**CITY OF SAINT PAUL
HERITAGE PRESERVATION COMMISSION STAFF REPORT**

FILE NAME: 2400 University Avenue West
APPLICANT: Joseph Bergman, Exeter Group LLC
OWNER: Flats Venture LLC
ARCHITECT: Jeremiah Smith, BKV Group
DATE OF APPLICATION: March 22, 2017
DATE OF PUBLIC HEARING: June 22, 2017
HPC SITE/DISTRICT: University-Raymond Commercial Heritage Preservation District
PERIOD OF SIGNIFICANCE: 1891-1941
CATEGORY: Contributing **WARD:** 4 **DISTRICT COUNCIL:** 12
INVENTORY NUMBER: RA-SPC-6301
CLASSIFICATION: Building Permit **ZONING:** T3
BUILDING PERMIT #:
STAFF INVESTIGATION AND REPORT: Alex Greenwood & George Gause
DATE OF REPORT: June 22, 2017

**RE: Design Review Application – University Avenue Storefront Windows & Doors (the “Application”)
Raymond Avenue Flats (the “Project”)
2400 University Avenue West, Saint Paul MN 55401 (the “Building”)**

NOTES:

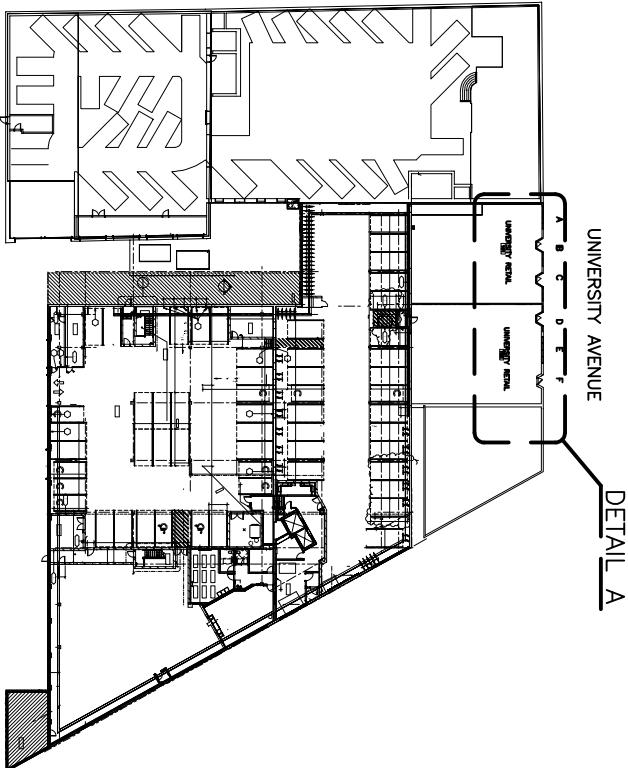
On June 19, 2017 the applicant provided photos and a written statement that indicates the condition of the wood that backs the historic metal storefront window jambs, sills, mullion, and header as deteriorated. The applicant also included a statement written by the contractor that indicates a difficulty with salvaging the trim to be reused and does not feel the trim could be removed and reapplied in the same plane on top of a new window system without damage.

- THERE WILL NEED TO BE SOME SILL REPAIR AT EXISTING KNEEWALLS DUE TO ROTTEN WOOD (THIS WOULD BE BY OTHERS). INTERIOR FINISHES INCLUDE SHEETROCK RETURNS TO FRAMES BY OTHERS.
- KNEEWALL ANGLES WILL NEED TO BE MODIFIED TO ACCEPT DOORS W/ 18" SIDELITES ON ALL OPENINGS. (KNEEWALLS BY OTHERS)
- IF EXISTING HORIZONTAL HEADER NEEDS TO BE REPLACED, EXISTING WOOD BLOCKING AT PERIMETER CLADDED WITH BREAK METAL COULD BE ELIMINATED. FRAME COULD BE HELD TIGHT TO MASONRY IN THIS CONDITION (A/7, B/7, C/7). NEW HEADER WOULD BE BY OTHERS. CLADDING OF NEW HEADER W/ DARK BRONZE ANODIZED BREAK METAL BY MINNEAPOLIS GLASS CO.

* ALTERNATE *

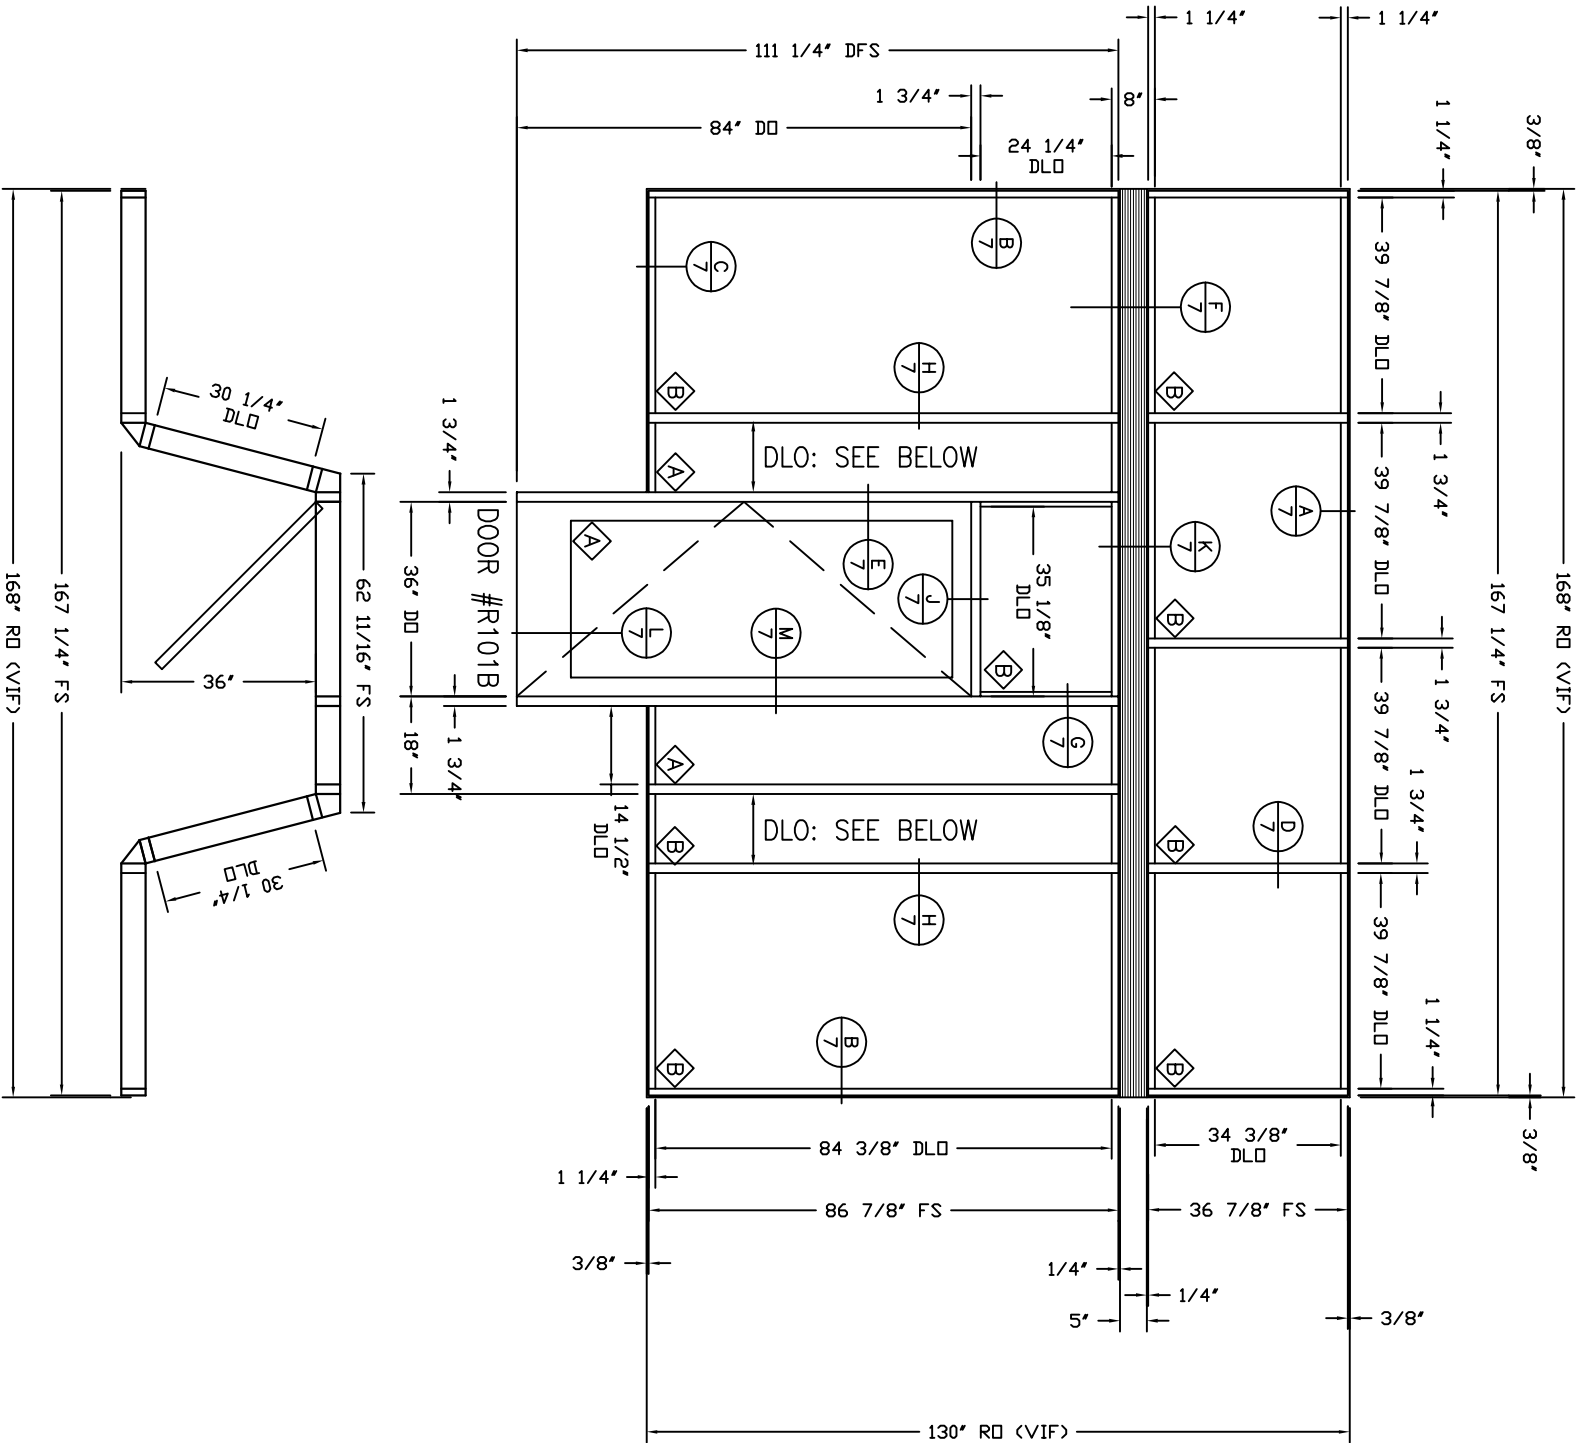
3. **Sec. 74.06.3(c)(2)(A):**
The proposal to install two alcoves that flank the center storefront window bays will result in the creation of two new door openings on the primary facade where they have not existed historically. The installation of a new alcove in Window bay 5 (third from the left) will remove the original storefront door opening that existed during the building's occupation by the General Motors Truck Company. In addition, the installation of the second alcove at window bay 1 (sixth from the left) and will remove the only remaining historic two-light storefront window and mullion that is extant from the building's initial construction in 1928. Furthermore, the detailing of the extant historic storefront framing features ornate coping and stamping in order to establish itself as the primary façade that faces University Avenue. The new proposed storefront system does not incorporate the replication of any coping details or stamping.

4. **Sec. 74.06.3(c)(2)(B):**
The proposed storefront window system will result in the complete removal and replacement of all extant historic fabric. The new systems would remove all historic transoms, sills, jambs, mullions, and muntins. While the new storefront systems are being proposed to offer improved functionality to the rehabilitated commercial spaces, they do not incorporate, or replicate the historic material, detailing, or functionality. Furthermore, the proposed operable windows do not respect the stylistic period of building as they do not match the general muntin and mullion proportions of the extant historic windows and do not respect the stylistic period as they change the original design intent of the static storefront windows.

5. **Sec. 74.06.3(c)(2)(C):**
Although the applicant is not proposing a window system that includes a storm window variant, the proposed operable windows require the remove of the existing, historic storefront windows. Furthermore the installation of track and latches would make a different set of alterations to the existing brick opening than a static storefront window system.

Based on the findings, staff recommends denial of the building permit application. Staff or the Commission could review and approve an approval that features the repair and retention of historic storefront material. Staff or the Commission could also review and approve an in-kind replacement that replicates the extant historic fabric and detailing.
